SYDNEY SWANS HQ & COMMUNITY CENTRE ROYAL HALL OF INDUSTRIES

RESPONSE TO GA NSW PLANNING SUBMISSION

PLANNING RESPONSE DOCUMENT – CMPT COMMENTS

3D Render from the intersection of Lang Road and Errol Flynn Boulevard

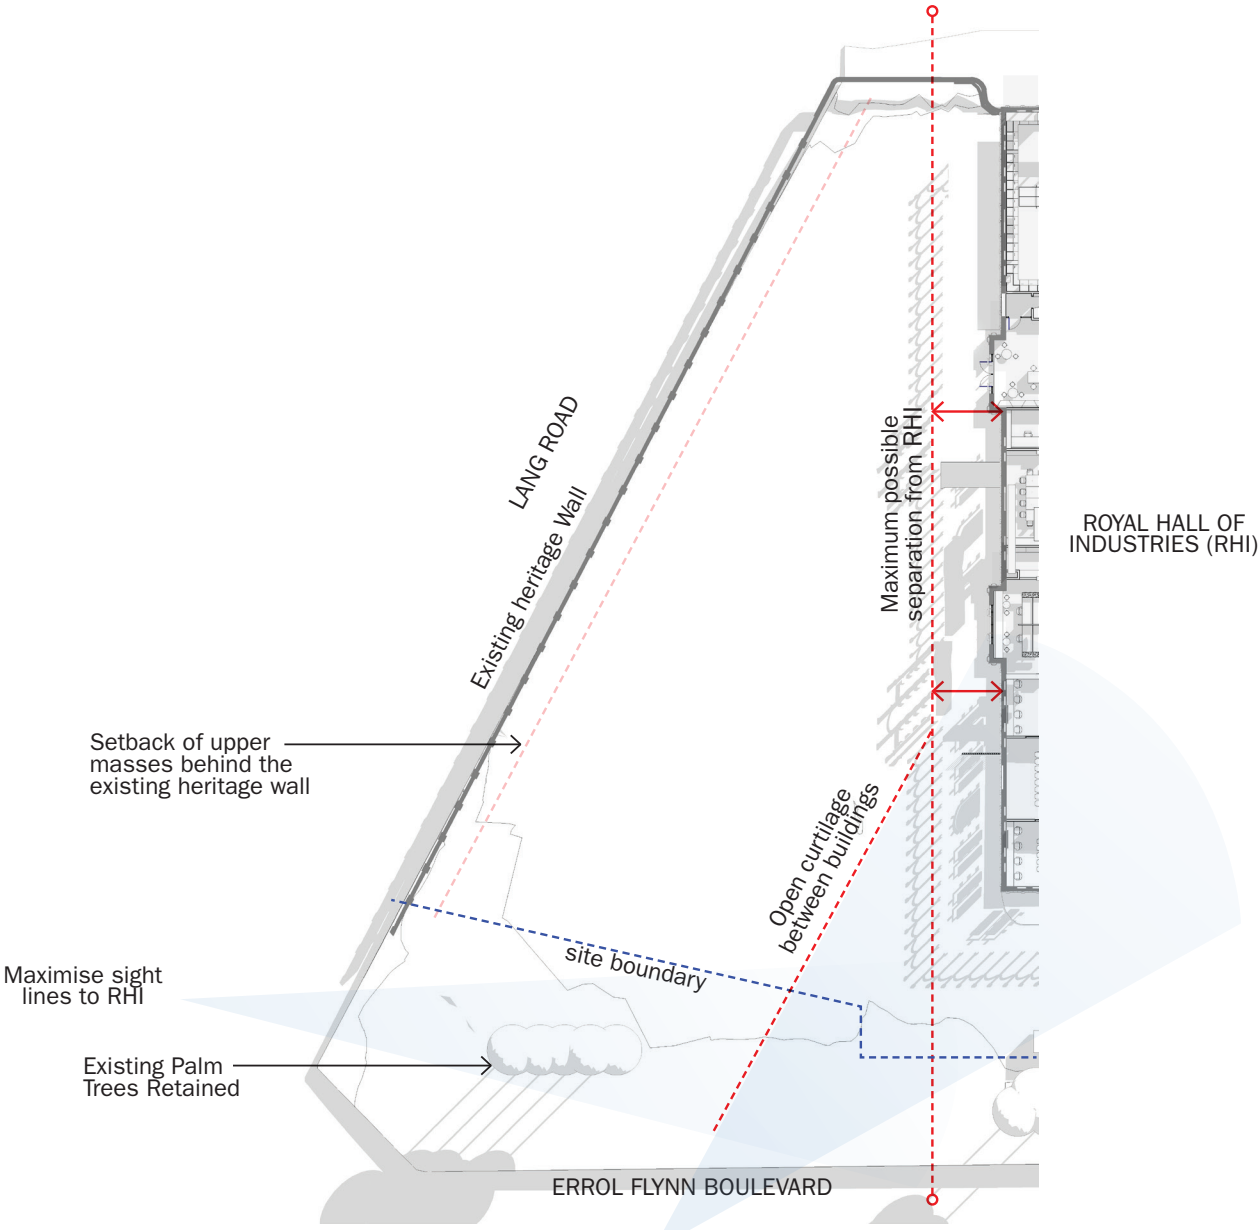
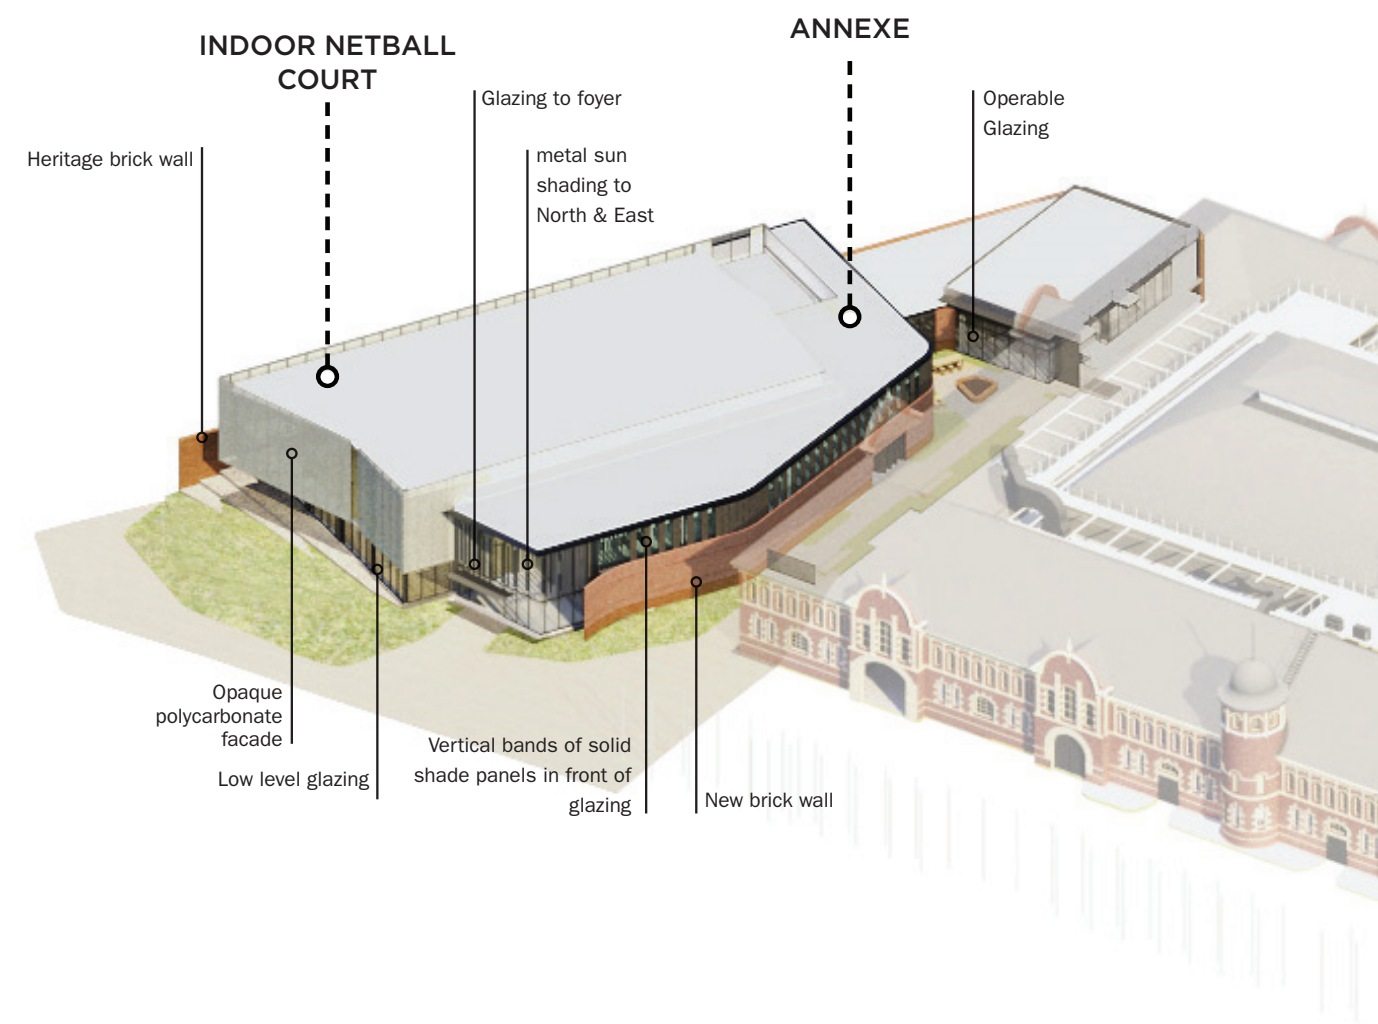
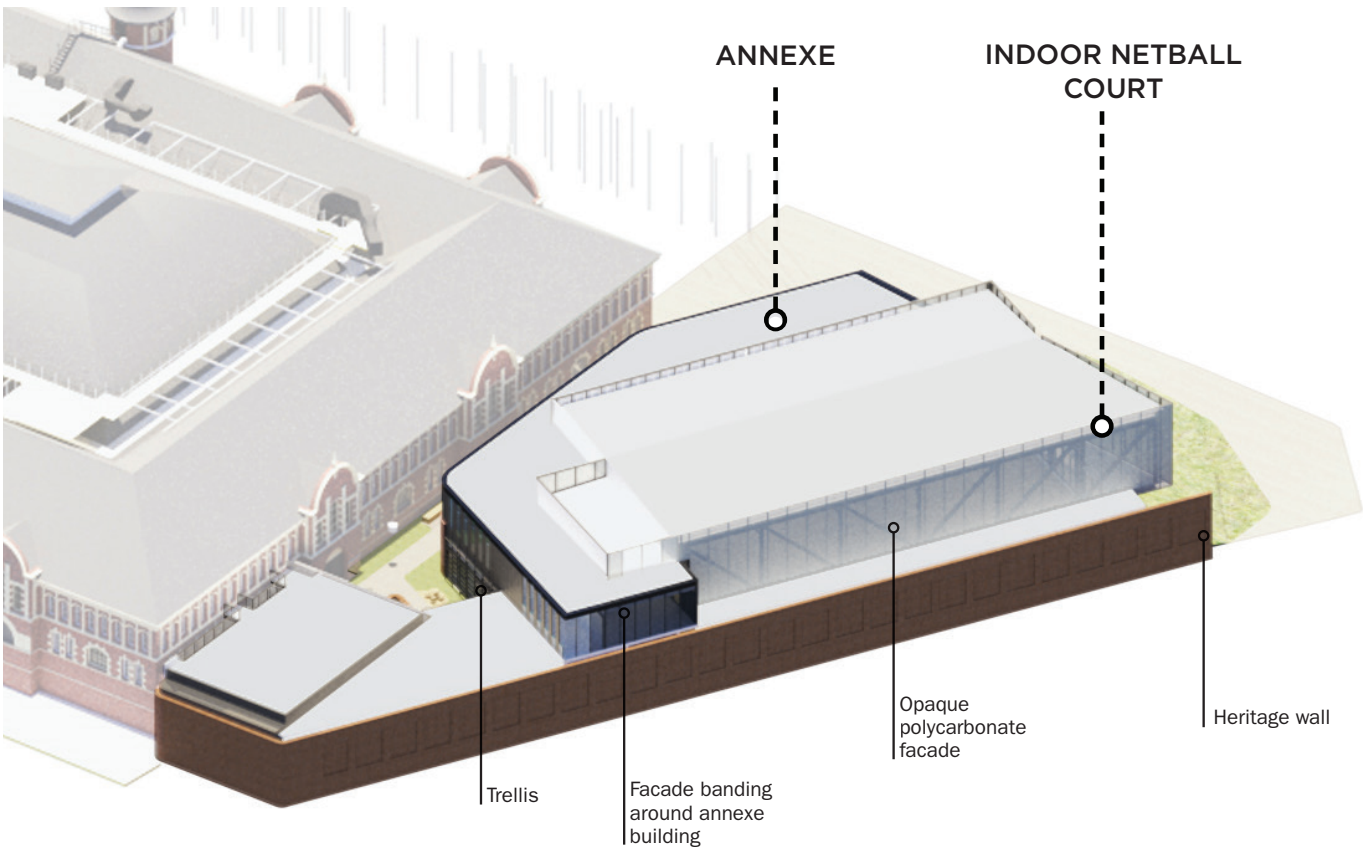
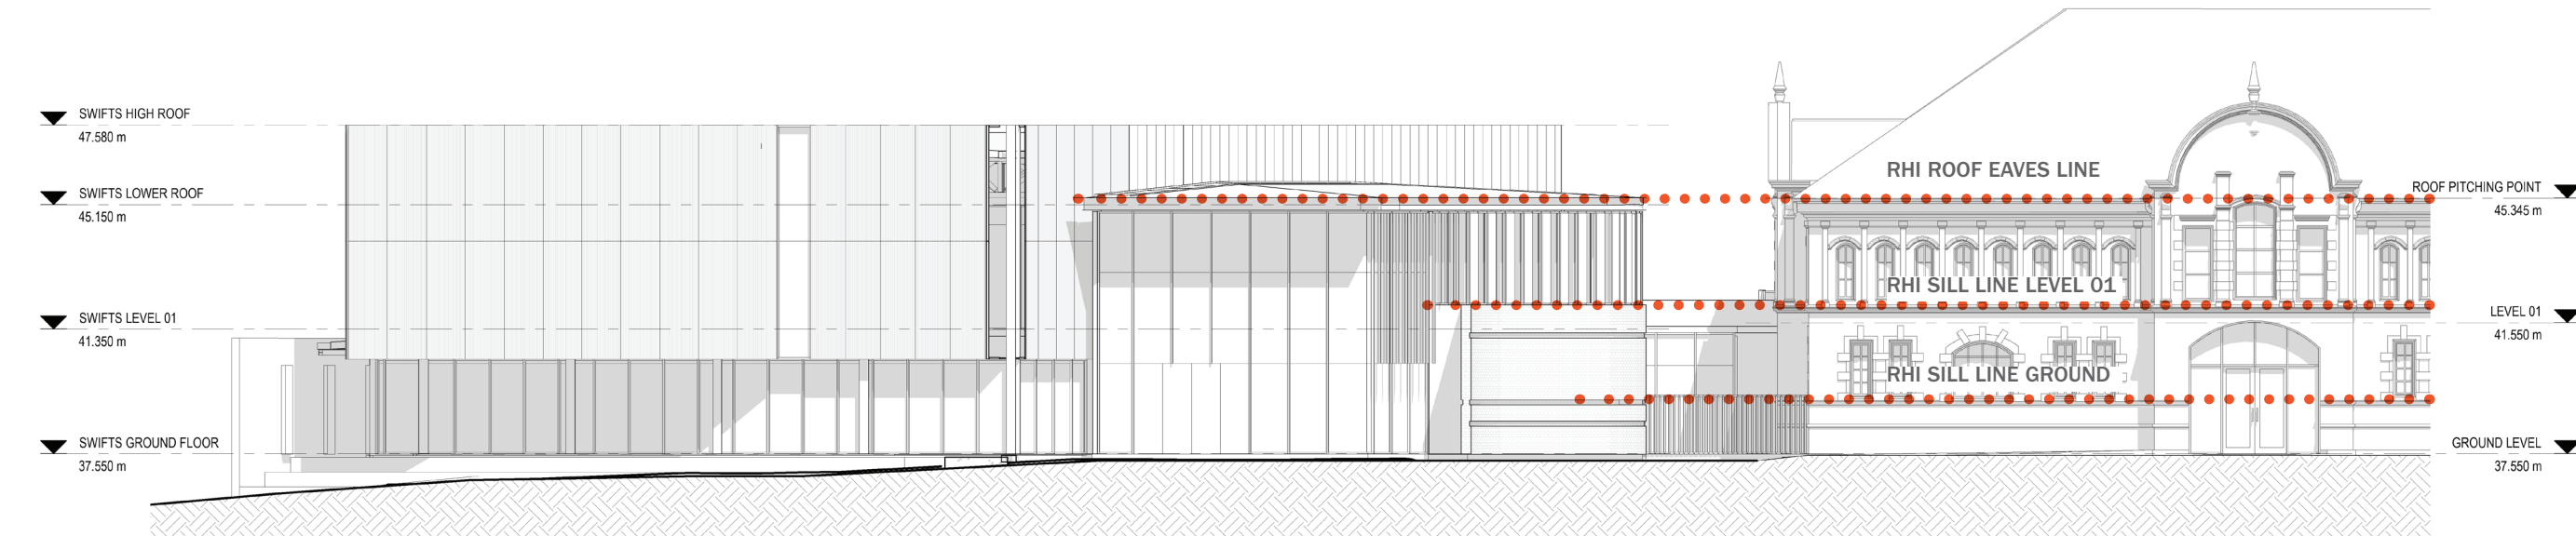
Articulate the façade of the NSB to reflect its corner location and entrance to the greater site.

The facade of the NSB is articulated with consideration to its corner location on Lang Road and Errol Flynn Boulevard and its location neighbouring the RHI.

Sight lines and setbacks were set from the beginnings of the design process to ensure the NSB design was respectful to its context (see plan below) Heights of the building mass were strategically chosen to mimic

existing RHI horizontal datum lines.

Further to this, the Northern shading panels facing the RHI follow the 1200mm centre to centre window rhythms of the RHI. The Southern facade of the NSB facing the parklands is a poly carbonate facade which is a plain facade during the day and a simple light box in the evening. This poly carbonate turns the corner onto the facade of Errol Flynn Boulevard. This design move is intended to enhance the arrival experience from Lang Road onto the entrance to the greater precinct.

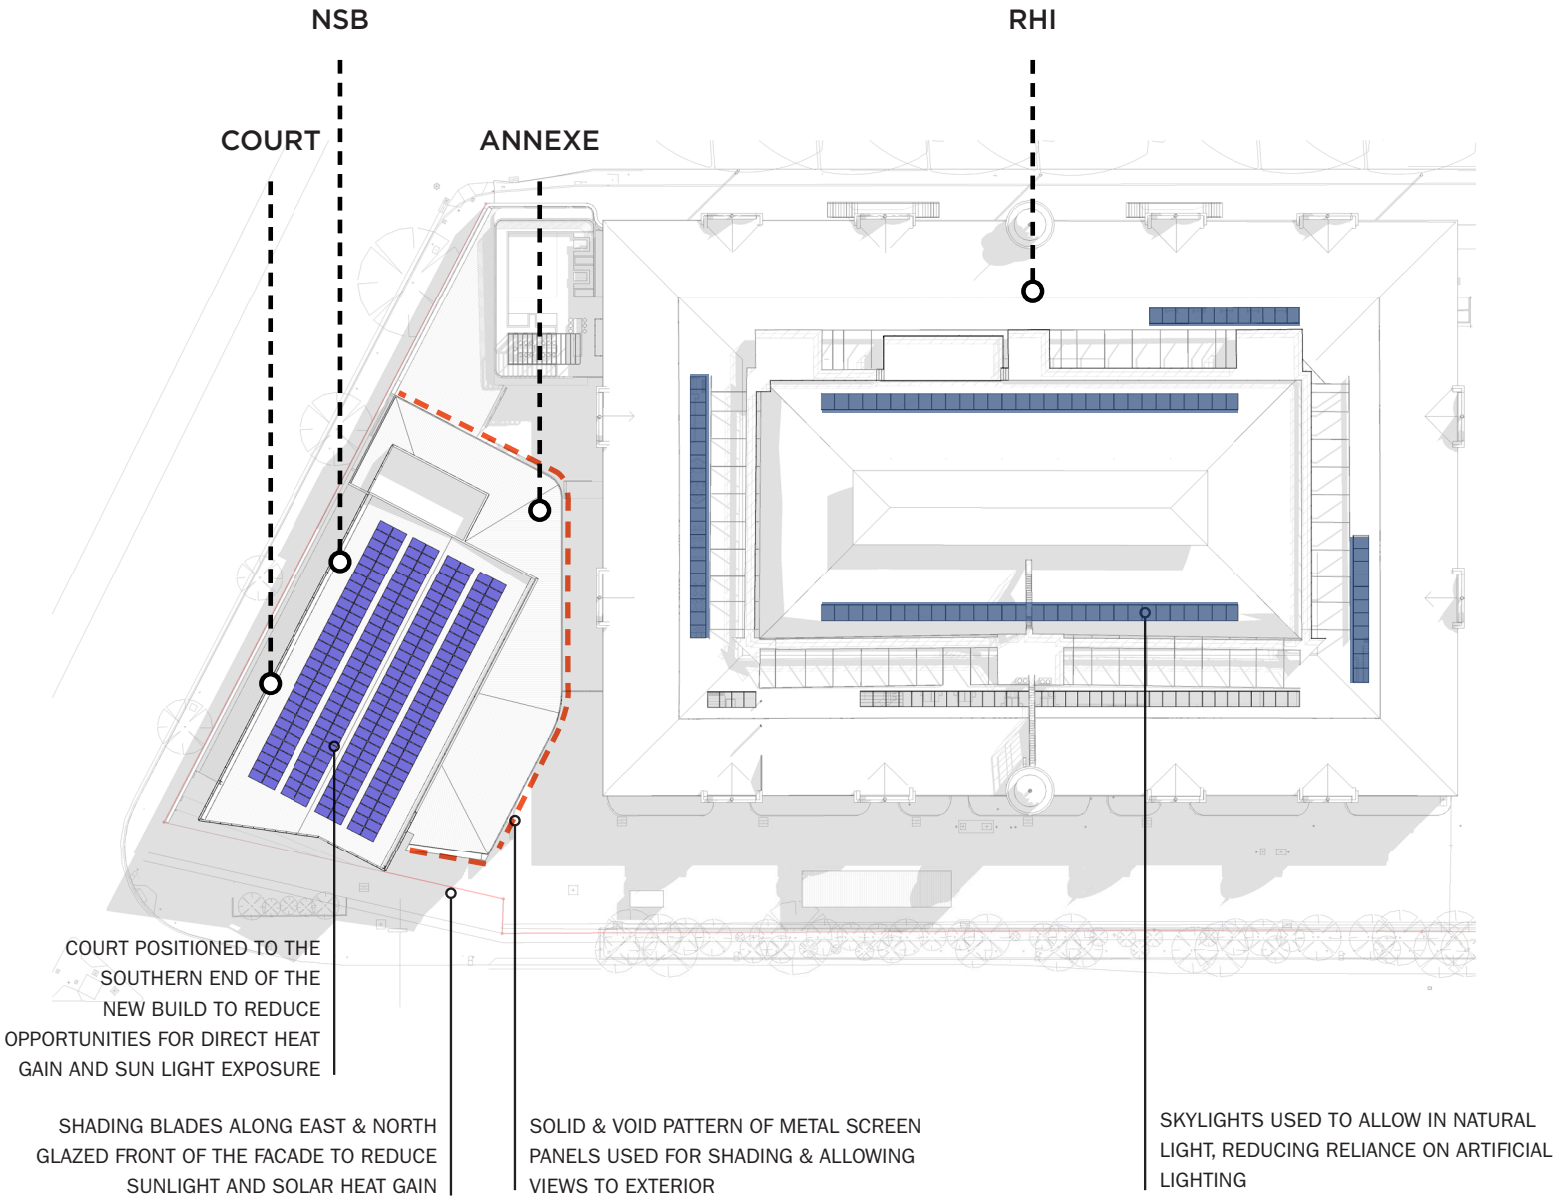
Articulate sustainability strategies to be incorporated into the RHI and NSB which demonstrate excellence in sustainability, in particular natural ventilation, appropriate solar protection and screening.

The overall aim of the building design is to consume minimal energy, and minimise its carbon footprint. There are a number of architectural strategies implemented in the design of the NSB & RHI (See images below)

- Overall planning strategies in siting and orientation of the NSB building plays a role in reducing overall heat gain and sunlight penetration into the netball court to reduce the need for mechanical systems.

- Number of shading strategies on the NSB are implemented along the South West facade and the shading blades along the Eastern foyer facade to reduce heat gain and sunlight penetration.
- The NSB's glazing with a minimum U value is strategically selected to improve thermal performance and comply with Section J requirements.
- The new works will include 250 x rooftop solar panels which support the NSB as well as the RHI. Water tanks

- are also incorporated for amenities.
- Sky lights are introduced into the RHI to improve natural daylight access and reduce reliance on artificial lighting

Figure 5. 3D view of the RHI and NSB from Driver Avenue

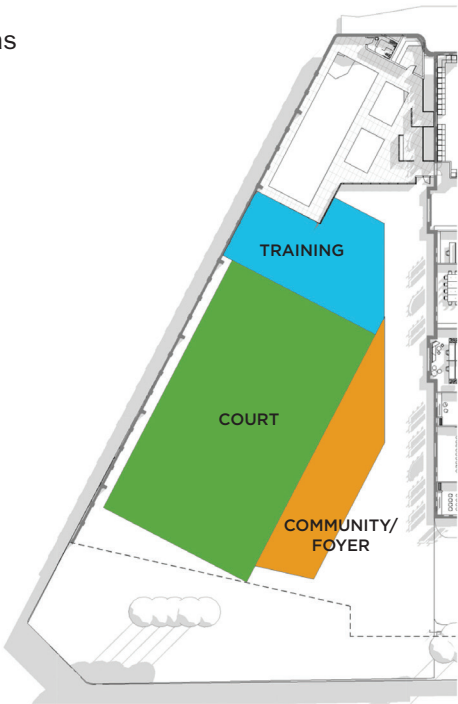
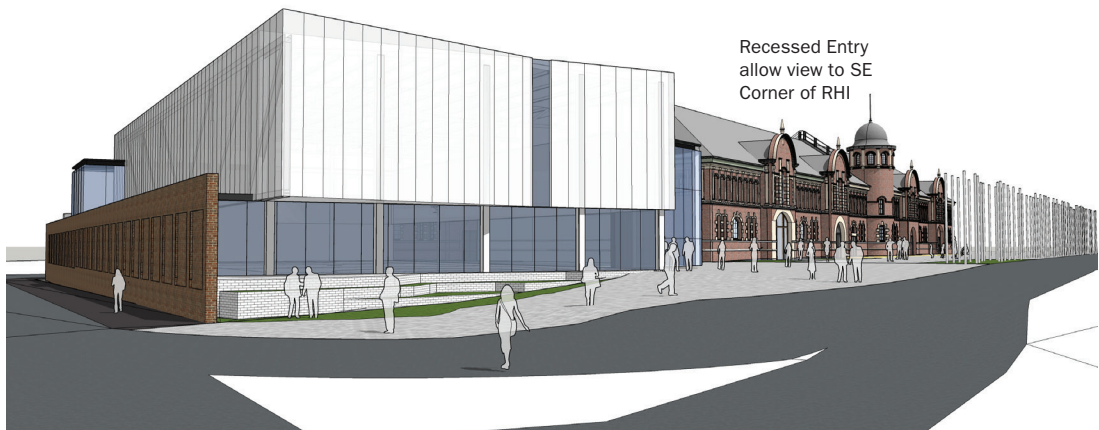
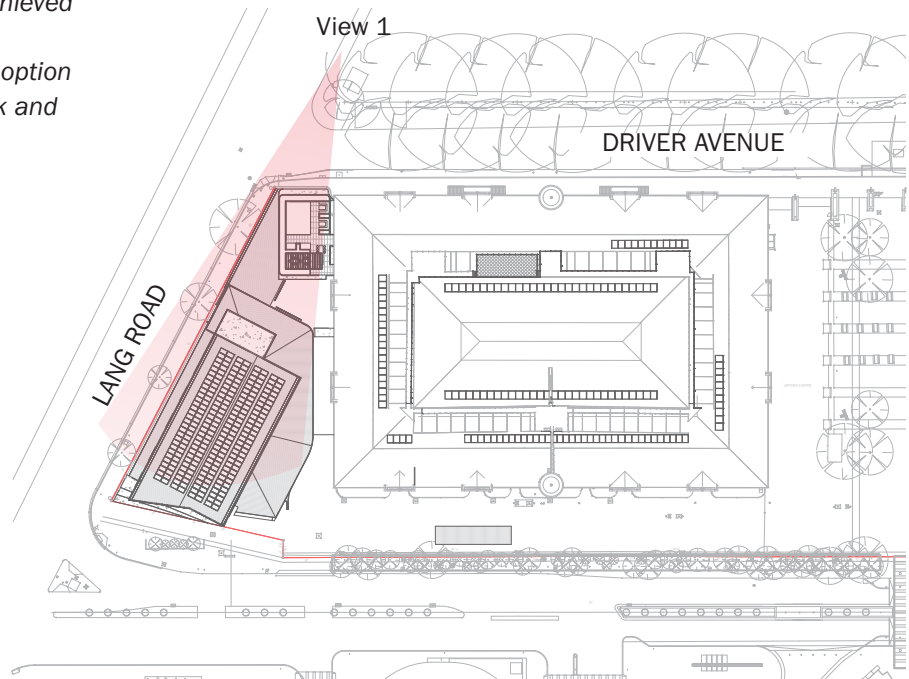
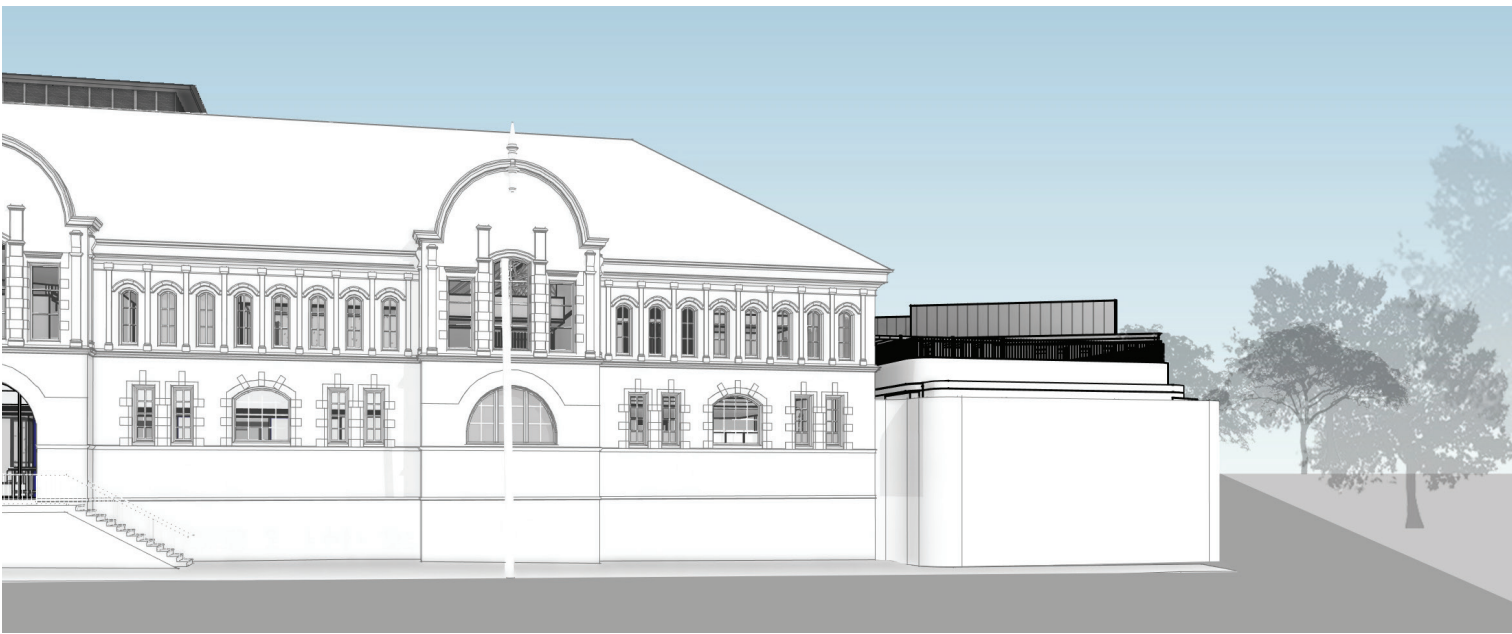
The Trust remains concerned that the detailed design of the NSW Swifts Building (NSB) establishes a potentially awkward and unsympathetic relationship between the strong symmetrical form and orthogonal geometry of the RHI.

The Trust notes the three massing options were studied primarily in terms of the relationship between the NSB and RHI when viewed from Errol Flynn Boulevard and Lang Road, but not when viewed from Driver Avenue - which is a critical vantage point for the presentation of the RHI to Moore Park and Anzac Parade particularly.

The Trust seeks clarification that the final preferred configuration of the NSW Swifts Building has achieved the support of the SDRP, and recommends that further investigation of the potential benefits of option 3 - when viewed from Driver Avenue, Moore Park and Anzac Parade - be undertaken.

Concerns regarding the architectural form and massing relationships between the NSB and the RHI were addressed in the exploration of three massing options (Figure 1, 2, 3). As noted the SSDA Report outlines the strengths and weaknesses of each in pages 147-160.

It was agreed with the SDRP in our second meeting with them (10 April) that, after exploring massing and their impact on desired sight lines, that Option 2 (Figure 2) was the preferred approach.

In response to Trust's concerns regarding the Driver Avenue vantage point please see 3D image below that illustrates that due the existing brick wall along Driver Avenue and the mass of the RHI itself the visibility of the NSB building is extremely limited, to the point where consideration of the relationship of the NSB to the RHI from that point is not critical as noted
